# DESIGN REVIEW/CERTIFICATE OF APPROPRIATENESS APPLICATION

PROPERTY IN	NFORMATION				
Project/Property Add			Project Name/Bus				
230 Granvill	e St, Gaha	nna, OH 43230	Sheetz Lincoln (	Circle / Sheetz, Inc.			
Parcel #: 025-00	4250	Zoning: (see <u>Map</u> ) <b>CC</b>		Acreage: Proposed 1.25 AC			
	200	PLAN SPEC	CIFICATIONS				
Application Type: (check all that apply)	■ Site Plan	Landscaping	■ Building Design	n Demolition Other			
Project Description:							
be surrounded by pa	arking and drive		fuel center. The n	with fuel center. The primary building will ecessary utilities to serve the site such			
		APPLICANT II	NFORMATION				
Applicant Name (Primary Contact): D	.W. Routte		Applicant Address: 4270 Morse Road, Columbus, Ohio 43230				
Applicant E-mail: <b>Droutte@skilkengol</b>	d.com		Applicant Phone: 614-418-3100				
Business Name (if applicable): Skilk	en Gold Real Es	tate Development					
		ADDITIONA	L CONTACTS				
	*Ple	ease list all applicable co		ondence*

Zoning File No. DR-0478-2023

Kelly: Please see the responses below in red to each comment presented in the 3-22-2024 comments for the Sheetz Lincoln Circle project.

RL-9308-S1-R3

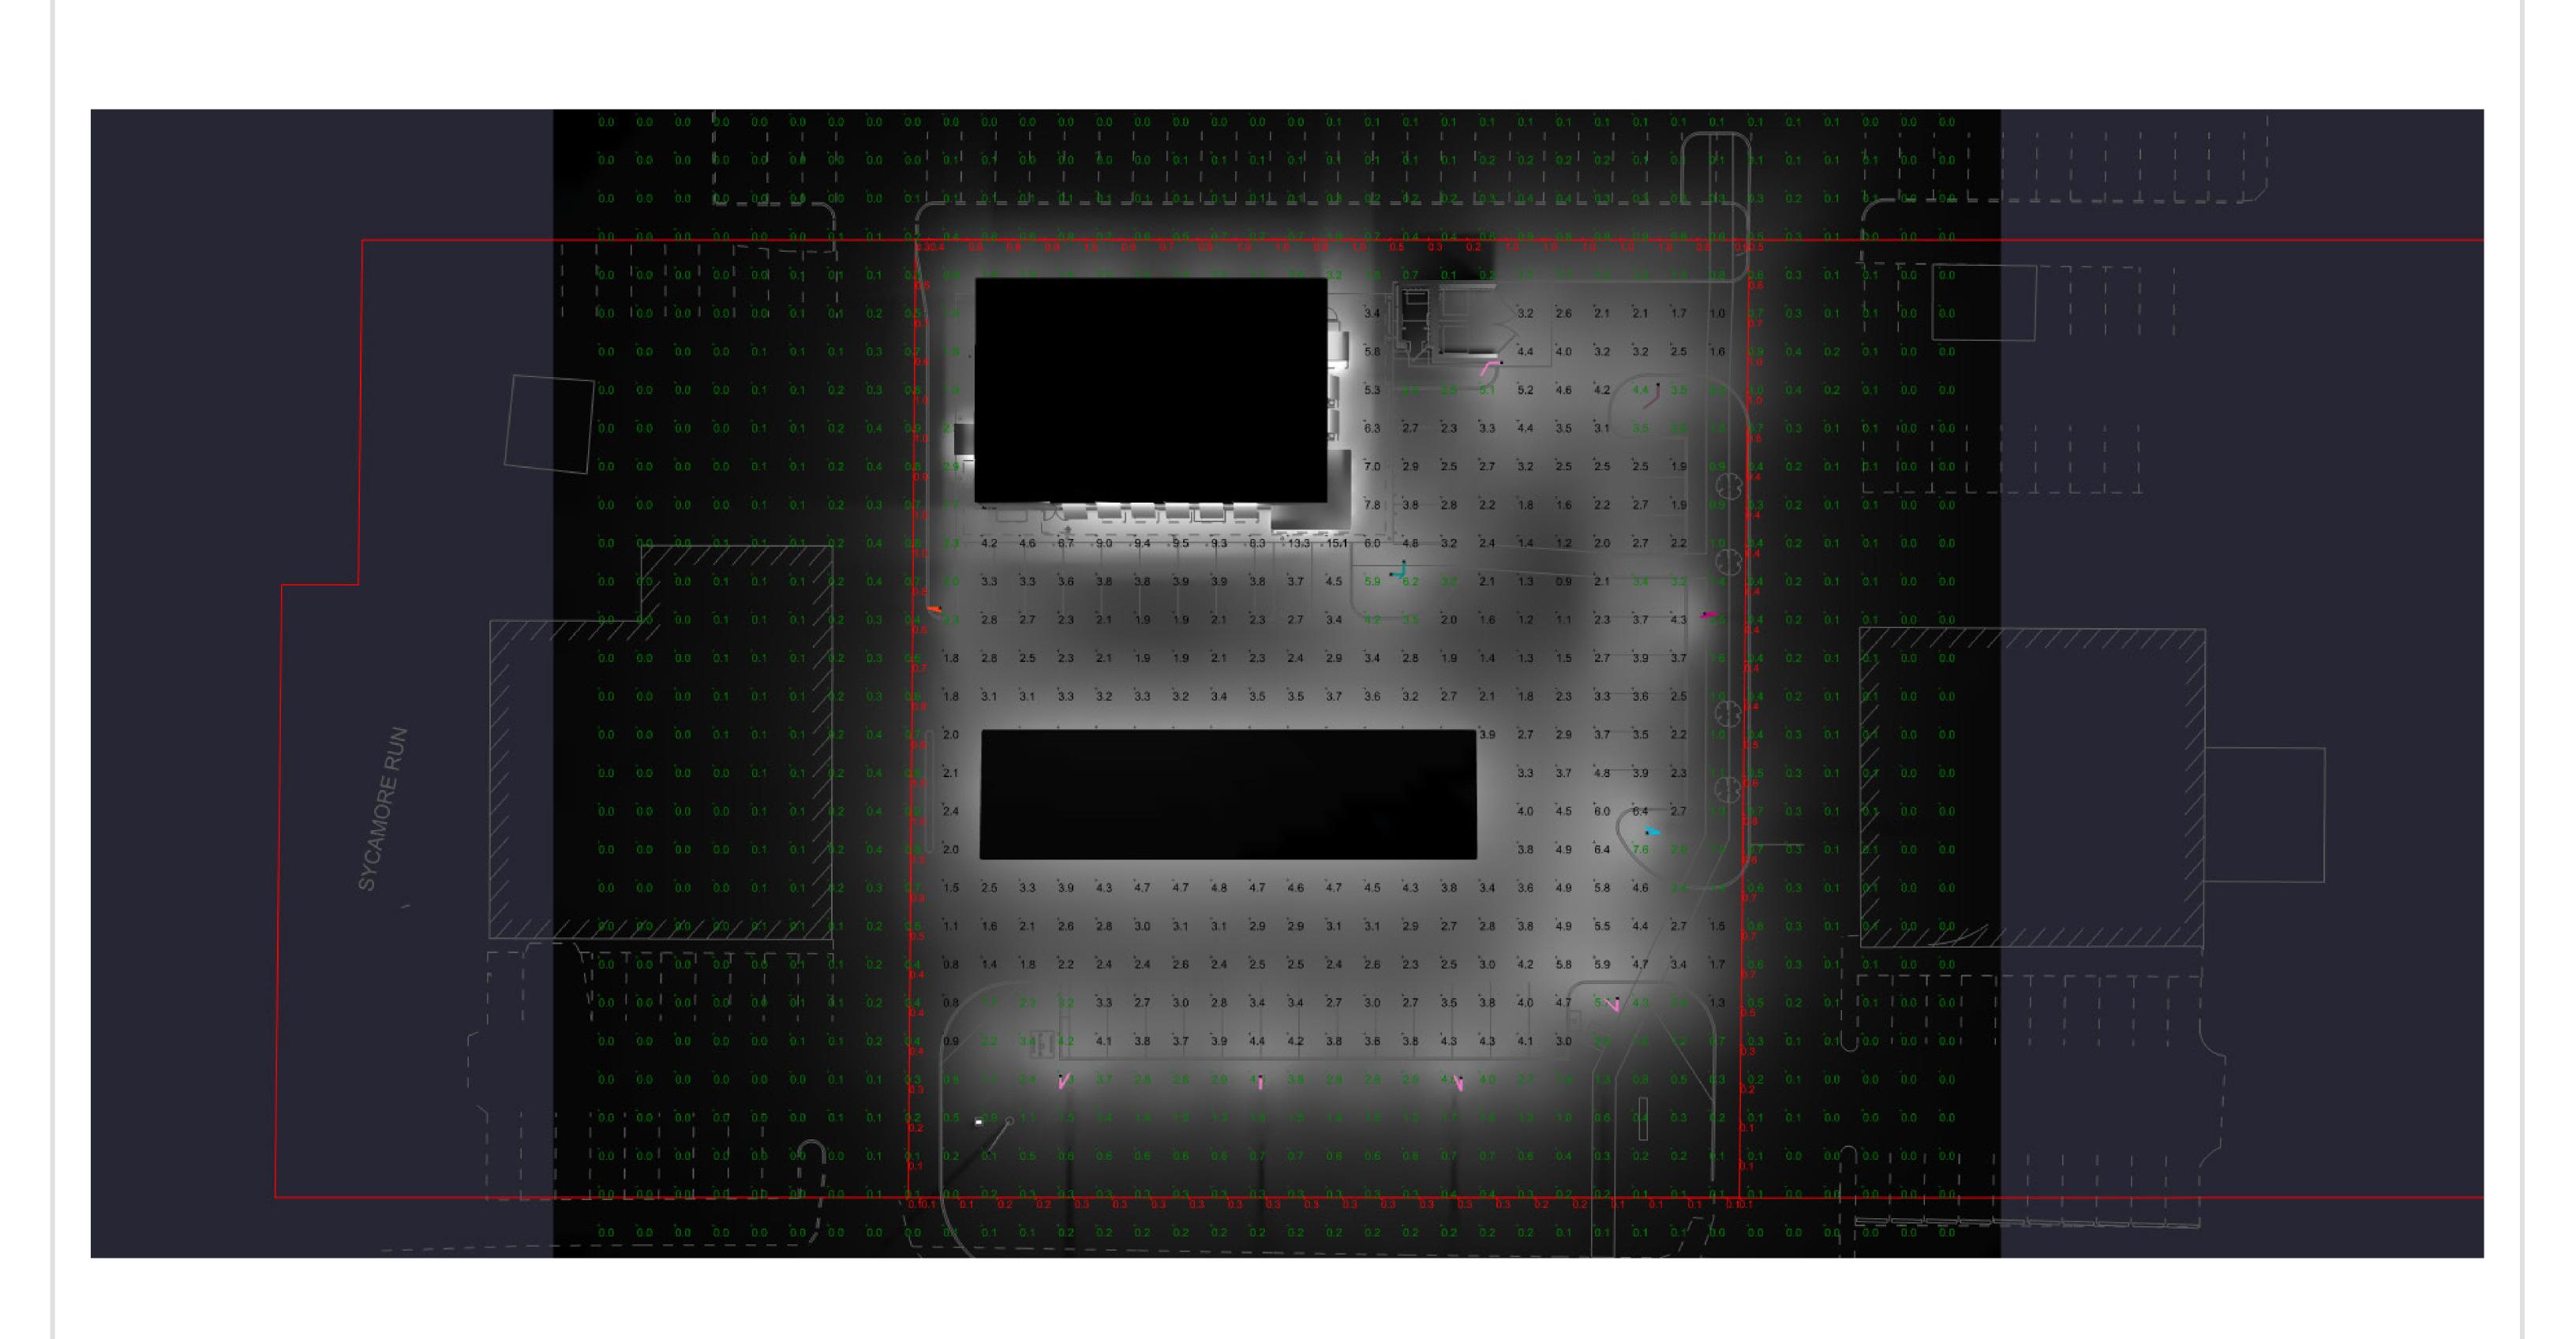
7. The submitted lighting plan is still not compliant with Code. Per Ch 1163.06(a), the foot candle value cannot exceed 1.0 fc at the property line. This is exceeded on the east property line. Please revise or apply for a variance.

-Revised per above comment.
